**FILE** P. I. No. 0006874, Cobb County  
CSCMQ-0006-00(874)  
Transit Supportive Sidewalks-North Cobb Pkwy

**SUBJECT** APPROVED PROJECT CONCEPT REPORT

**SUBJECT: PROJECT CONCEPT REPORT**

**FROM:**  Glenn Bowman, P.E., State Environmental/Location Engineer  
**TO:** Genetha Rice-Singleton, Assistant Director of Preconstruction  
**SUBJECT: PROJECT CONCEPT REPORT REVIEW**

**SIDEWALK ADDITIONS TO  
BOTH SIDES OF ROAD, WITH 2' STAMPED  
CONCRETE**

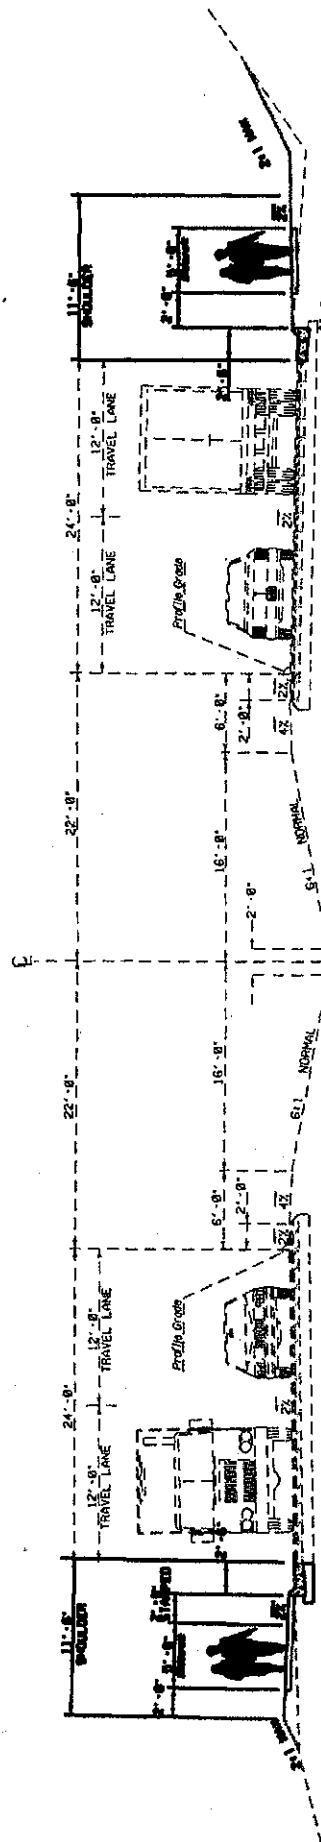
8. Typical Section

- a. Show 2% slope in sidewalk to alleviate gutter spread
- b. Show type 2 curb and gutter
